RESPONSE TO COUNCIL SUBMISSIONS

BAY CENTRAL

CAPTAIN COOK DRIVE, WOOLLOOWARE

MAY 2016

LEVEL 1
AMENDED MODIFICATION PROPOSAL
ARTICULATION CAPTAIN COOK DRIVE

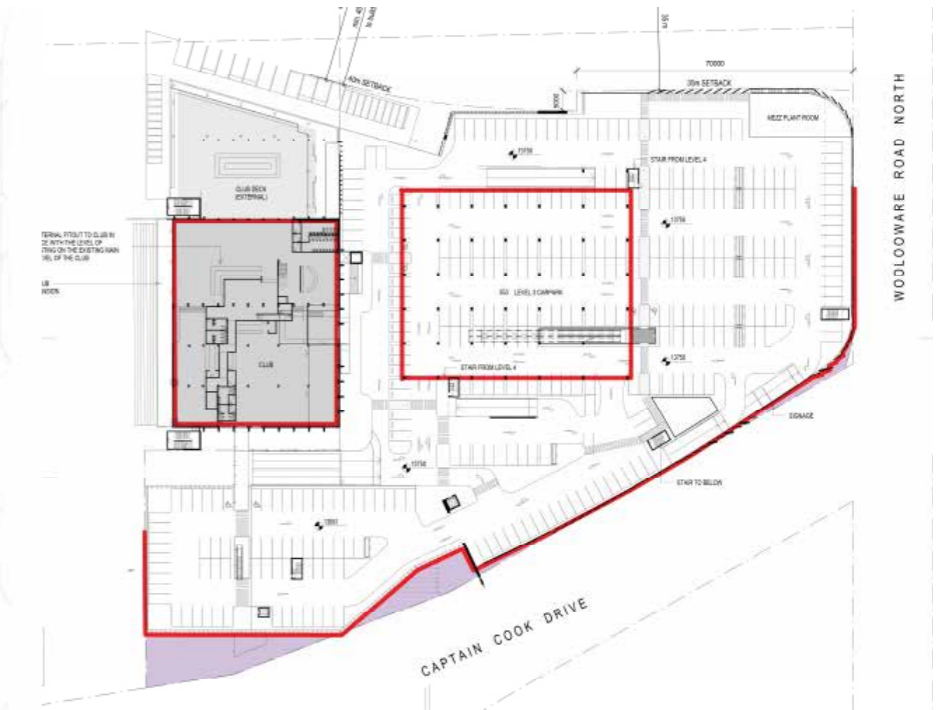
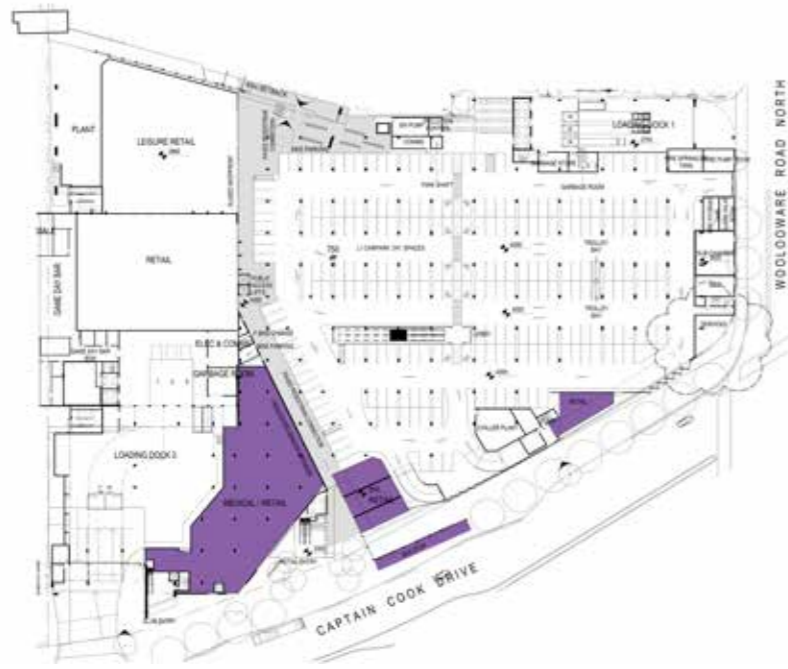
FACADE ARTICULATION IS PROVIDED BY A SERIES OF STEEL FRAMES WHICH ORDER THE FACADE ELEMENTS ON BOTH THE NORTH AND SOUTH ELEVATIONS CONNECTING THE ELEVATED STREET WITH THE SAME STEEL SHROUD WHICH THEN HOUSES THE RETAIL SHOPFRONTS. THE EXTERIOR AND INTERIOR EXPRESSION IS THEREFORE ONE ELEMENT WHICH LINKS INSIDE TO OUTSIDE ORGANIZING ALL ELEMENTS WITHIN IT. THIS ELEMENT ORDERS WITHIN IT ACTIVATED ZONES BOTH PHYSICALLY AND VISUALLY AND PROVIDES A VISUALLY STRONG AND CONSISTENT ARCHITECTURAL EXPRESSION AT BOTH MACRO AND MICRO SCALES WITH MODULATION BOTH IN PLAN AND ELEVATION APPROPRIATE TO ITS CONTEXT.

ACTIVATION CAPTAIN COOK DRIVE
AMENDED MODIFICATION PROPOSAL

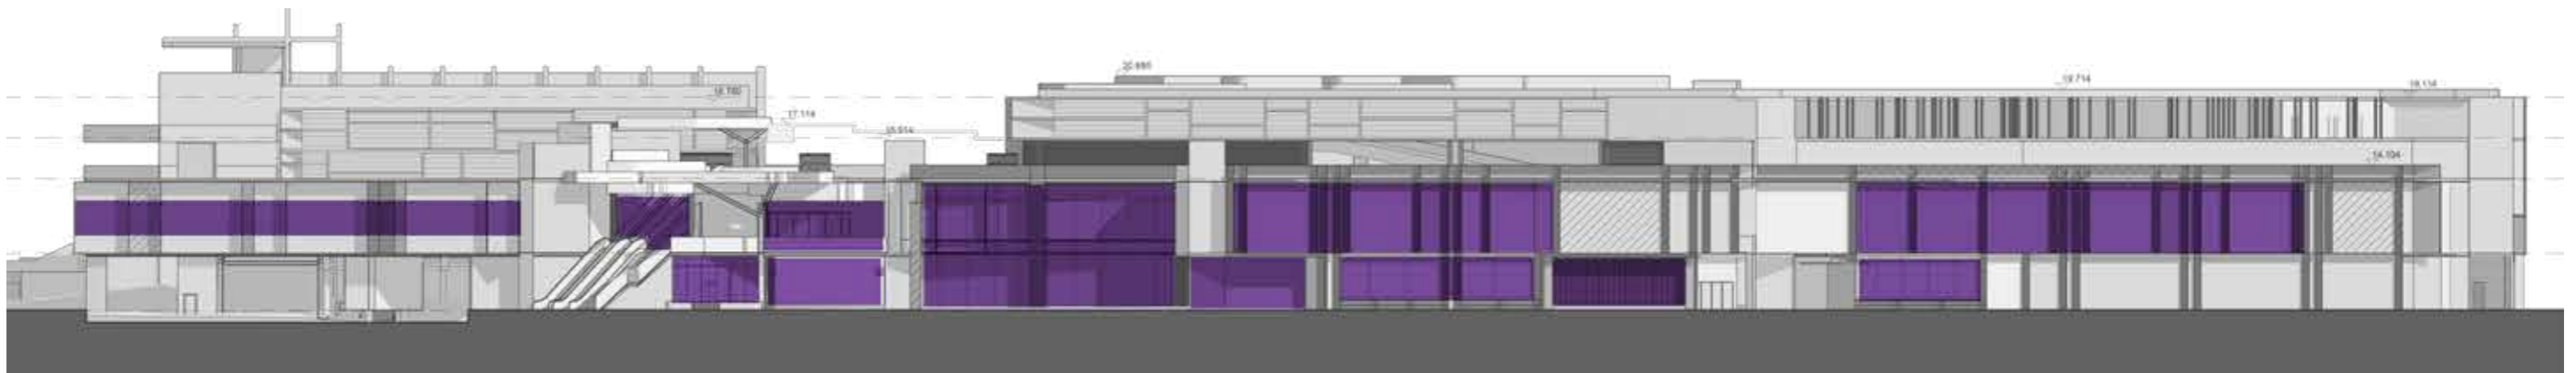
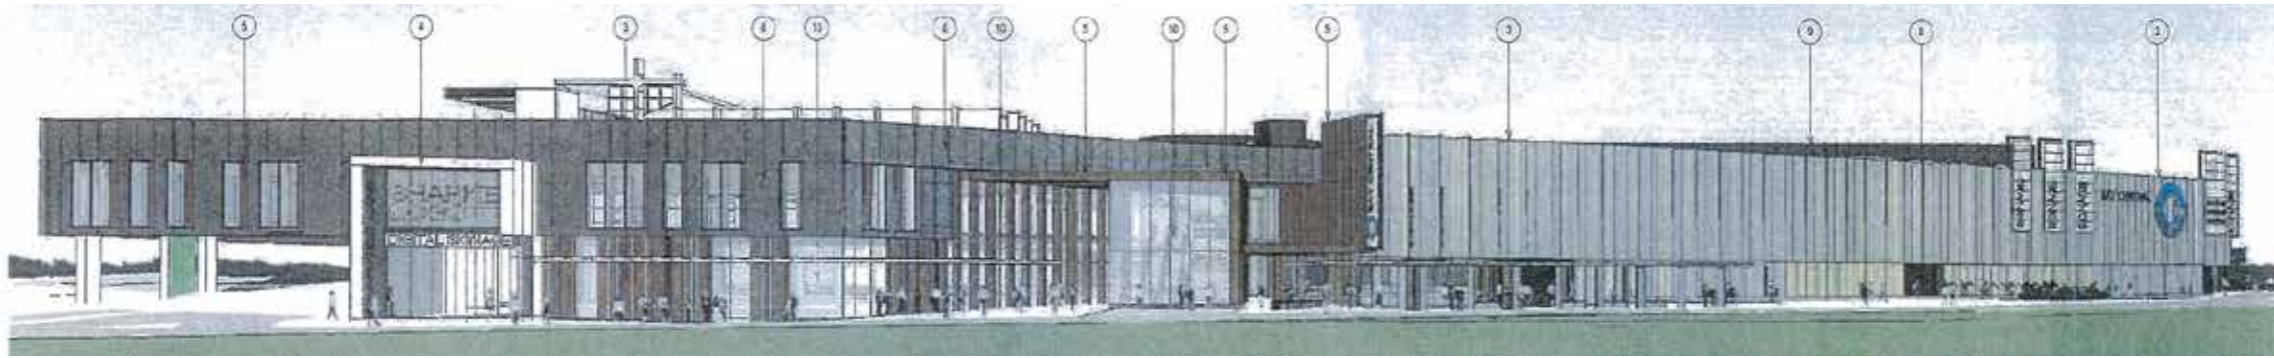
THE CARPARK LEVEL HAS BEEN EXTENSIVELY REDESIGNED TO ACHIEVE A MUCH HIGHER PROPORTION OF ACTIVATION NOT ONLY HORIZONTAL-
LY BUT AS IMPORTANTLY VERTICALLY GIVING VISUAL INTEREST TO THE ENTIRETY OF THE FACADE. ACTIVATION HAS BEEN ACHIEVED BY NOT
SIMPLY PROVIDING RETAIL SHOPFRONTS ALONG THE STREET EDGE BUT RATHER A SERIES OF EXPERIENCES: A MAJOR ICONIC ENTRY POINT; AN
ARTICULATED THROUGH SITE LINK WITH CLEAR AND OPEN SIGHT LINES, A TWO LEVEL COMMUNITY CENTRE, AN INTEGRATED BUS SHELTER,
THE OPPORTUNITY FOR POP UP RETAIL AND PROVISION FOR A SIGNIFICANT LOCAL ART PIECE.

NORTH ELEVATION TO RIPARIAN ZONE

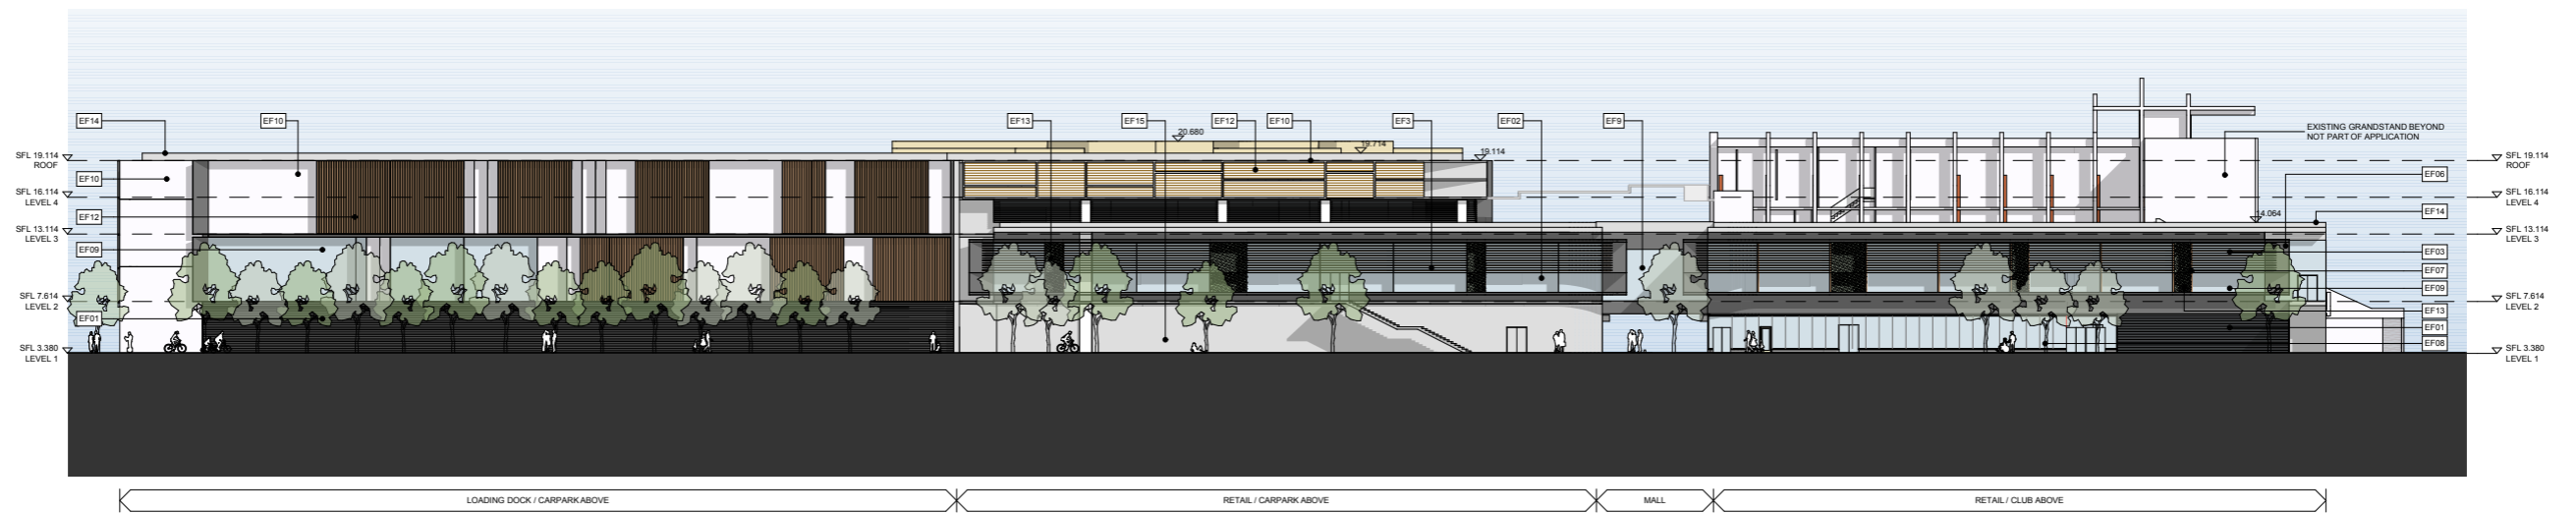
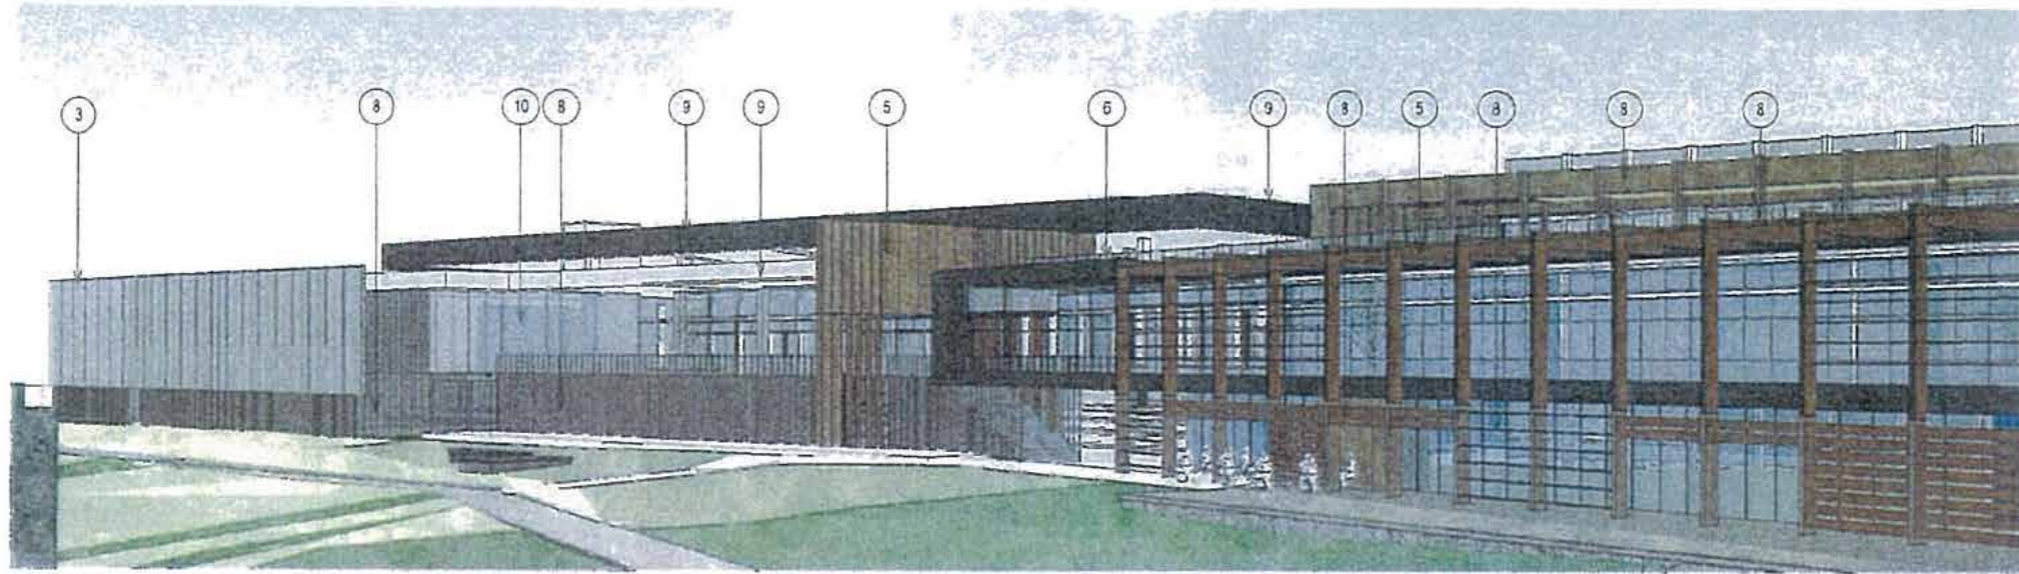
THE ARTICULATION OF THIS FACADE IS AN EXTENSION OF THE ARCHITECTURAL DIALOGUE WHICH STARTS ON CAPTAIN COOK DRIVE AND IS DRAWN THROUGH THE ELEVATED STREET BEFORE CONNECTING OUT TO THE RIPARIAN ZONE. ARTICULATED STEEL FRAMES ORDER THE VERANDAH EDGE AS IT OPENS TO THE AIR AND LIGHT WHILE PROVIDING A SMALLER SCALE MODULATION FOR PEOPLE TO SIT AGAINST AND APPRECIATE THE VIEW. THE ABILITY TO OPEN AND CLOSE THE FACADE AT THIS POINT ALLOWS INCREASED AMENITY TO THE DINING TERRACE WHILE STILL MAXIMIZING VIEWS, SUN AND AIR AND IMPORTANTLY CONNECTION TO PUBLIC OPEN SPACE. THE PROPOSAL TO PROVIDE A LANDSCAPED AMPHITHEATER WHICH CONNECTS THE ELEVATED TERRACE TO THE PUBLIC DOMAIN PROVIDES ARTICULATION TO THIS EDGE AND FURTHERS THE SEAMLESS INTEGRATION BETWEEN LANDSCAPE AND THE BUILT FORM
